SERVICE BULLETIN NO: 35-004

MODIFICATION NO: 030413

OXYGEN - PASSENGER OXYGEN OXYGEN PIPES - CHANGE THE ROUTING POSITIONS

Modification of the Aft Pipe Routing
 Figure 1

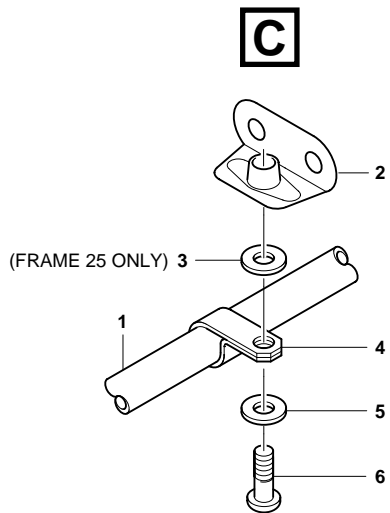
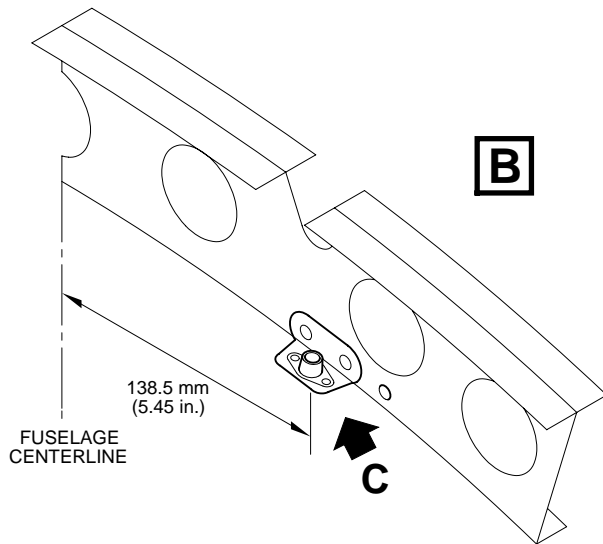
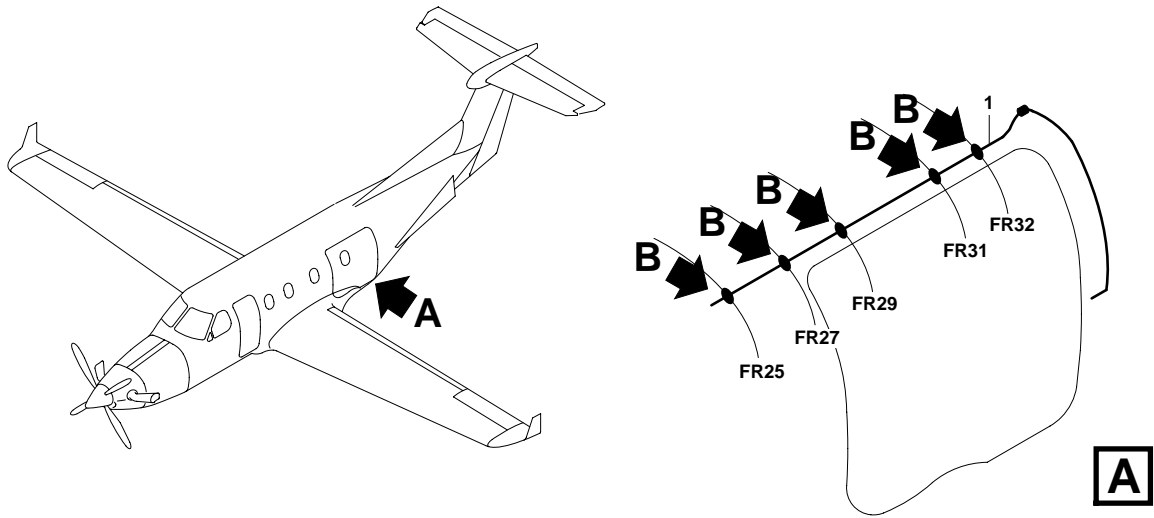
F. Modification of the Attachment of the Aft Oxygen Pipe (Fig. 1)

This procedure is applicable only to the eight-seat oxygen system.

- (1) Obey the safety precautions given in AMM, 35-00-00, Page Block 201.
- (2) Disconnect the pipe (1) (535.21.12.054).
- (3) Remove the screws (6), washers (5), the clamps (4) and the pipe (1). On Frame 25 remove washer (3) also.

- (4) Install blanks in the open ends of all disconnected aircraft oxygen pipes.
- (5) Remove the two rivets that attach the five oxygen-pipe angle brackets (angle) (2) to Frames 25, 27, 29, 31 and 32 (Ref. SRM 51-40-01, Page Block 1). Remove the angles (2).

- (6) Move one of the angles (2) inboard and align the outer hole of the angle with the inner hole in the Frame (where you removed the rivets in Step (5)).

- (16) Install a rivet (P/N: 939.17.81.018) in the remaining rivet hole in Frames 25, 27, 29, 31 and 32 (Ref. SRM 51-40-01, Page Block 1).
- (17) Remove the blanks from the oxygen pipes and connectors.
- (18) Put the pipe (1) in position, turned approximately 90 degrees from the initial position and loosely connect it at each end.
- (19) Put the clamps (4) in position on the pipe (1) and install the washers (5) and the screws (6). On Frame 25, install also washer (3).
- (20) Tighten the connections of the pipe (1).

Modification of the TCAS Antenna Cable Routing
 Figure 2

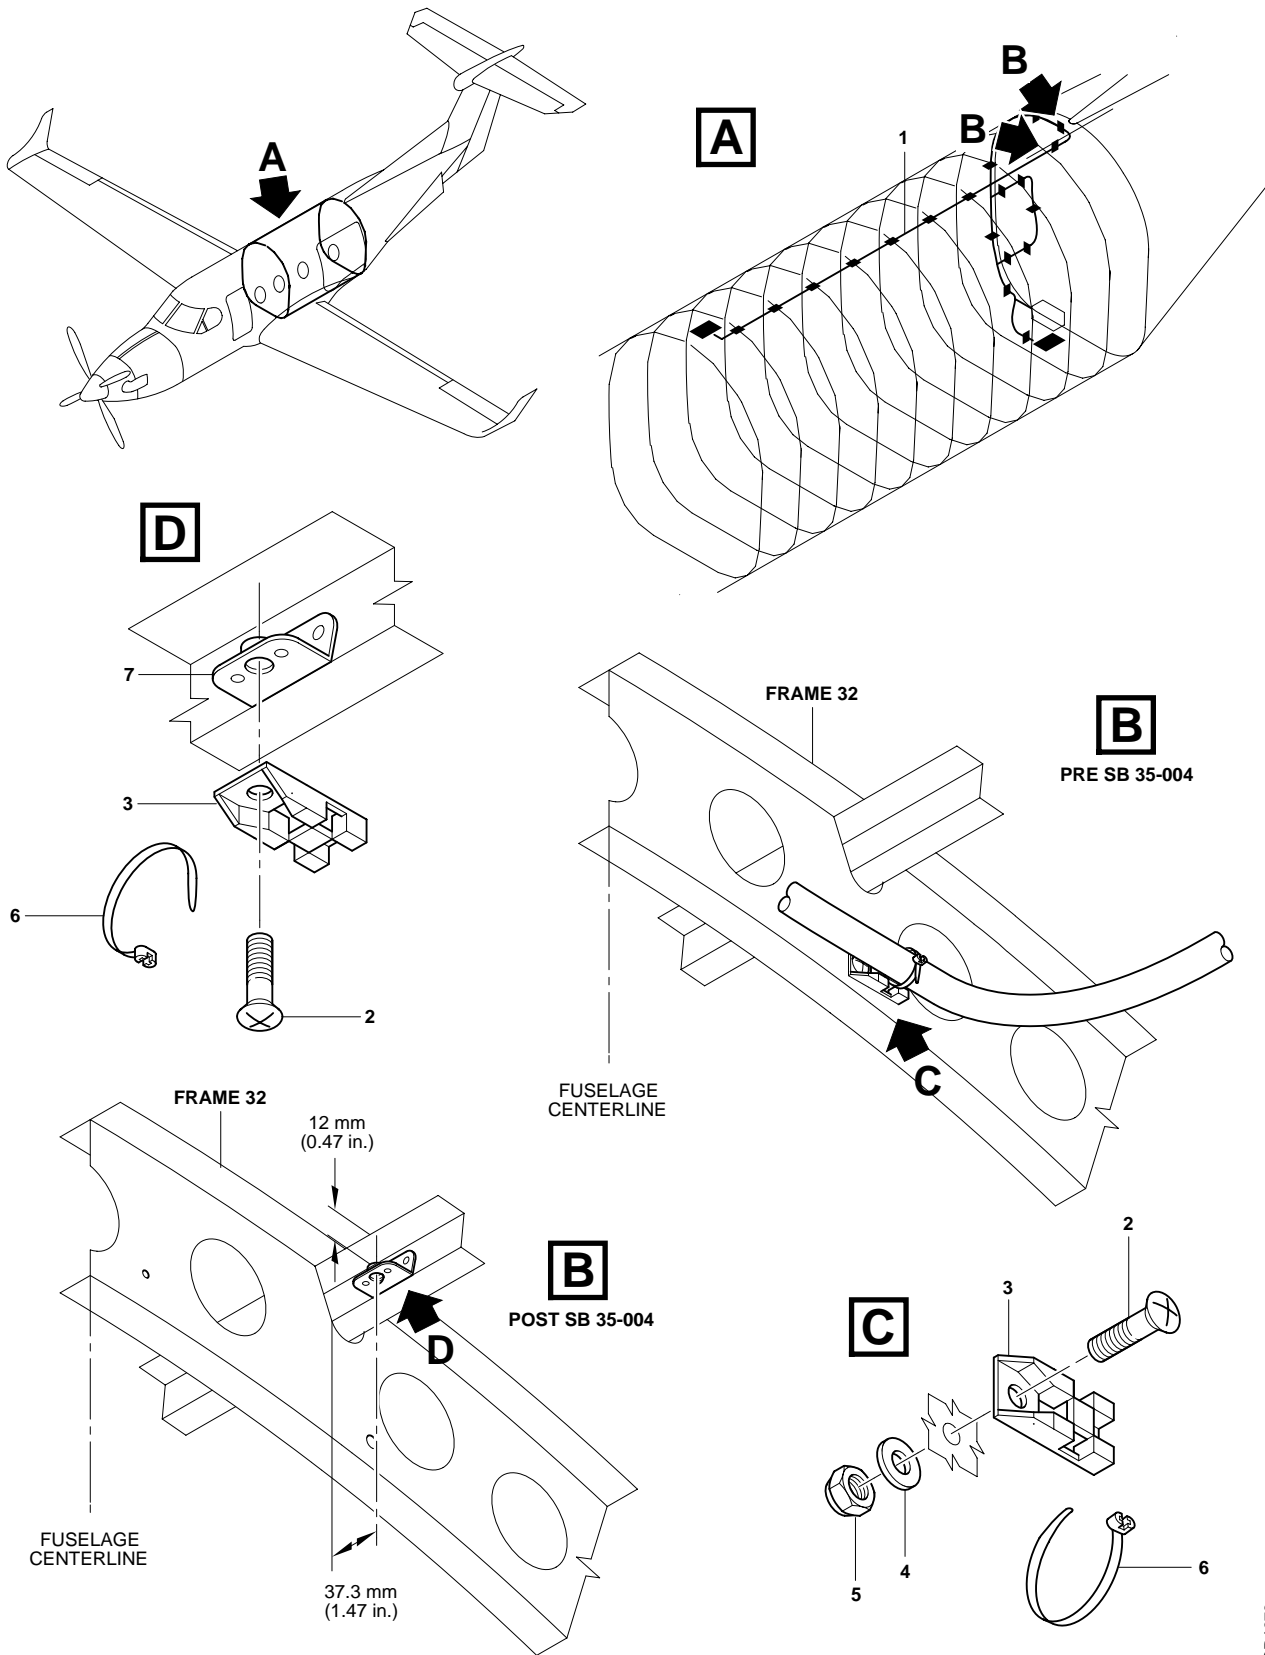
E. Modification of the TCAS Antenna Cable Routing (Fig. 2)

This procedure is only applicable to aircraft with the TCAS antenna installed and the eight-seat oxygen system.

- (1) Remove and discard the cable tie (6).
- (2) Remove the screw (2), the washer (4), the nut (5) and the mounting base (3). Discard the nut (5) and washer (4).
- (3) Put the new mounting angle (7) in position. Use the holes in the angle (7) as a template to make marks on the stringer for the two rivets.

- (4) Remove the angle (7).
- (5) Use a 0.13 in. (3,3 mm) diameter drill to make new holes where you made the marks at Step (3).
- (6) Deburr the new rivet holes you made at Step (5).
- (7) Obey the manufacturers instructions and apply a layer of Alodine 1200S (Item No. P07-001) to the bare metal of the holes in the stringer.
- (8) Put the angle (7) in position and install the two rivets (P/N: 939.17.81.018) to attach the angle to the stringer (Ref. SRM 51-40-01, Page Block 1).
- (9) Put the mounting base (3) on the mounting angle (7) and install the screw (2).
- (10) Move the antenna cable (1) to the new position.
- (11) Attach the antenna cable (1) to the mounting base (3) with a new cable tie (6).
